# CHAPTER 8 Response to Comments

# RTC CHAPTER 1 Introduction

This document has been prepared to respond to comments received on the joint Draft Environmental Impact Report/Environmental Impact Statement (EIR/EIS) prepared for the Potrero HOPE SF Master Plan Project (Proposed Project). The Draft EIR/EIS identifies the likely environmental consequences associated with the implementation of the Proposed Project and recommends mitigation measures to reduce significant impacts. This Responses to Comments document provides a response to each comment received and revises the Draft EIR/EIS, as necessary, to correct or clarify information.

POTRERO HOPE SF MASTER PLAN (CASE NO. 2010.0515E)  
FIGURE 4.3-1: VIEWPOINTS LOCATION MAP

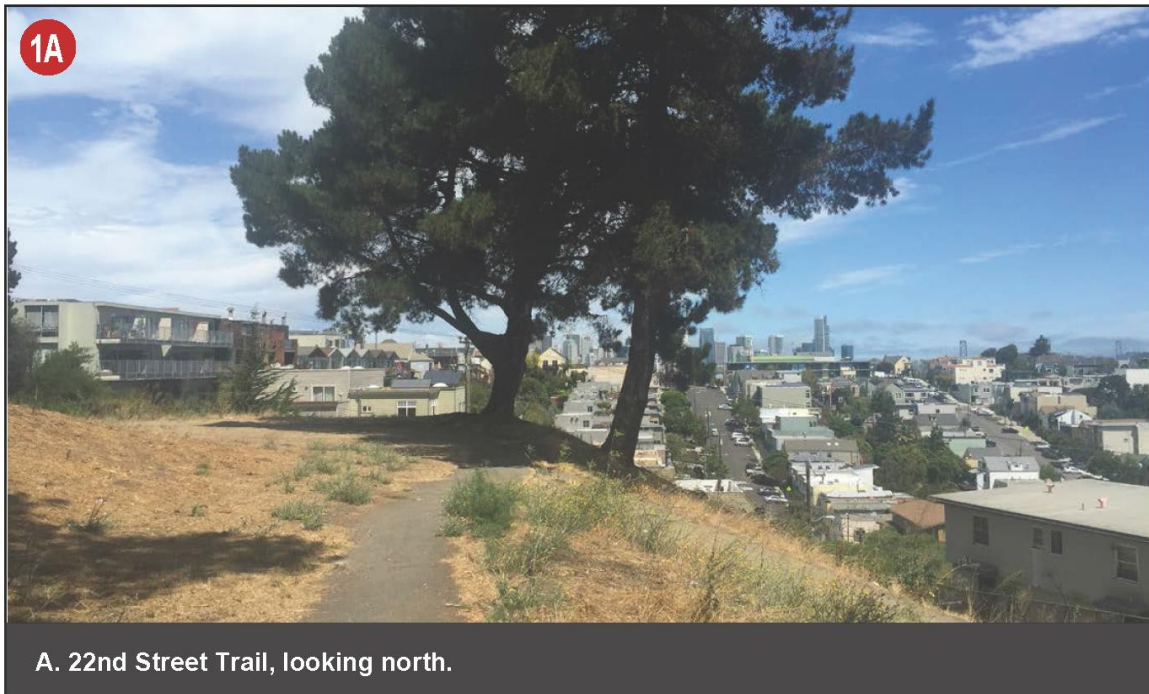
viewer locations, which include parks, publicly accessible buildings, and sidewalks that offer a view of the urban and natural landscape making up a viewshed. Since the preparation of the Draft EIR, additional views from these vantage points have been added to the analysis, including from the eastern terminus of the 22<sup>nd</sup> Street Trail, the bench below the tennis courts, and the Potrero Hill Recreation Center. The views from each of these nine vantage points are depicted on Figure 4.3-1 and Table 4.3-1 of the revised analysis.

POTRERO HOPE SF MASTER PLAN (CASE NO. 2010.0515E)  
FIGURE 5.3-9: PROPOSED PROJECT, 23RD STREET AT WISCONSIN STREET, LOOKING EAST (VIEWPOINT 3)

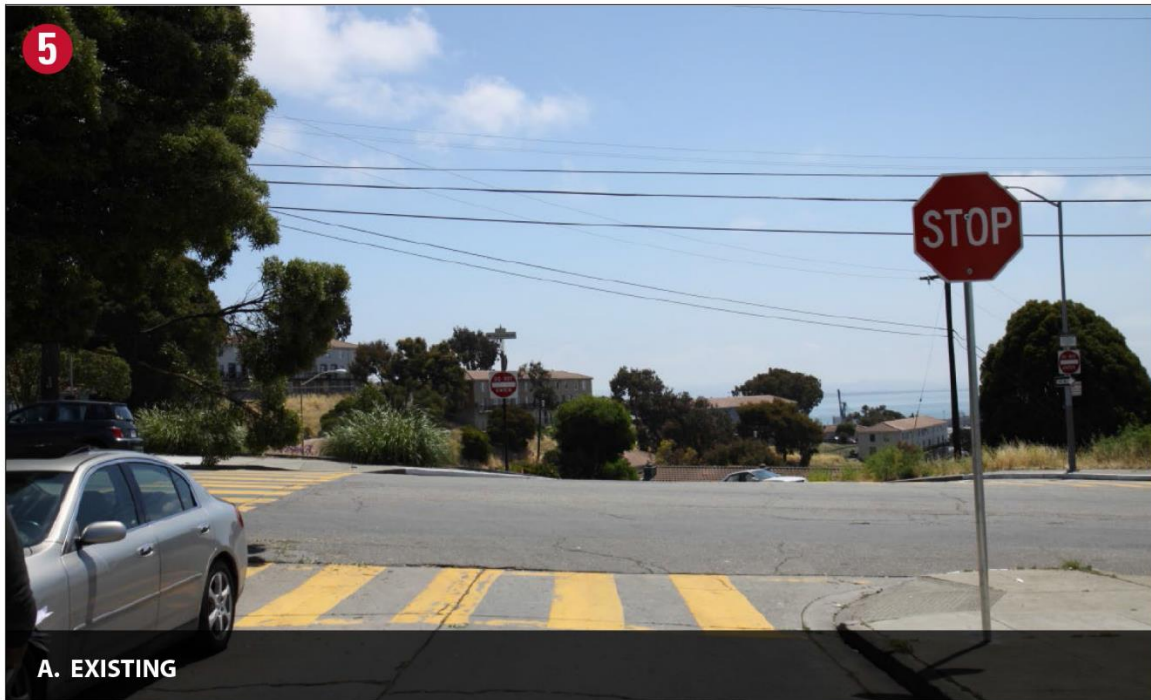
*Intersection of 23<sup>rd</sup> Street and Wisconsin Street (Viewpoint 3)*. As shown in ~~Figure 5.3-3~~ Figure 5.3-9 Photo A (Viewpoint 3), the existing foreground view facing east on 23<sup>rd</sup> Street consists of multi-family residential units to the north of 23<sup>rd</sup> Street, street pavement, overhead utility wires and poles, and a chain-link fence surrounding the Project site. The middleground views encompass mature trees at the Recreation Center, minimal vegetation at the Project site, and the roofs of the existing buildings at the Project site. Background views of the Bay (Viewpoint 3) and ridgelines (Viewpoint 4) are limited due to intervening vegetation and structures. The views from Viewpoint 4 of the distant ridgelines open up and become more expansive as a motorist or pedestrian travels south, but because the views would be of short duration, viewer ~~sensitivity~~ response to changes in views from Viewpoint 3 would be low to moderate from ~~Viewpoint 3~~. Currently, there is little visual unity between the Project site and its surroundings, as noted.

However, the Proposed Project, as shown in ~~Figure 5.3-3~~ Figure 5.3-9 Photo B, would construct multi-family residential buildings that would be visually compatible with the existing residences on the other side of 23<sup>rd</sup> Street. Although these buildings would be approximately 40 feet, which is taller than the existing structures, they would be stepped downhill to follow the slope of the terrain, making them appear to be approximately of equal height. In addition, the existing utility wires and poles on-

POTRERO HOPE SF MASTER PLAN (CASE NO. 2010.0515E)  
FIGURE 5.3-15: PROPOSED PROJECT, VIEW FROM I-280 (VIEWPOINT 9)

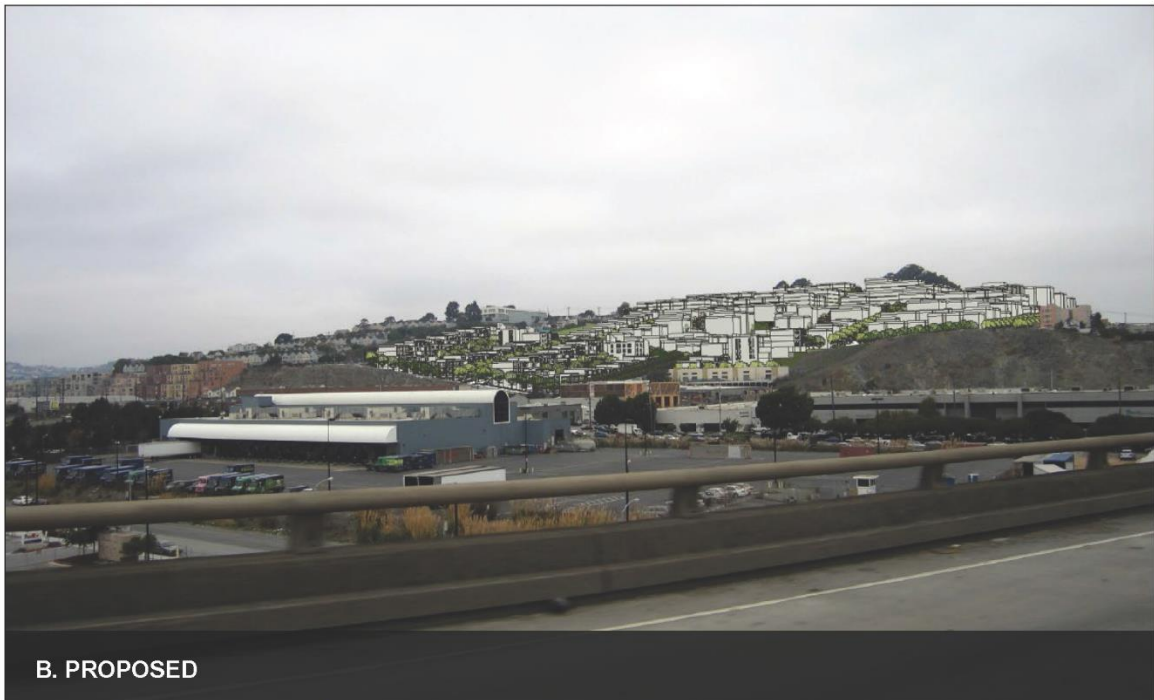
Figure 5.3-15 of the revised analysis illustrates the Reduced Development Alternative from I-280. The commenter is correct that part of the Project site (the west side) does not look well articulated when compared to the east side of the site. The boxy forms shown in the eastern portion of the Project are presented to only to illustrate the general massing that is proposed. Upon buildout of the Project, it is anticipated that the articulation would be similar to what is shown in the western side of the site in this figure.
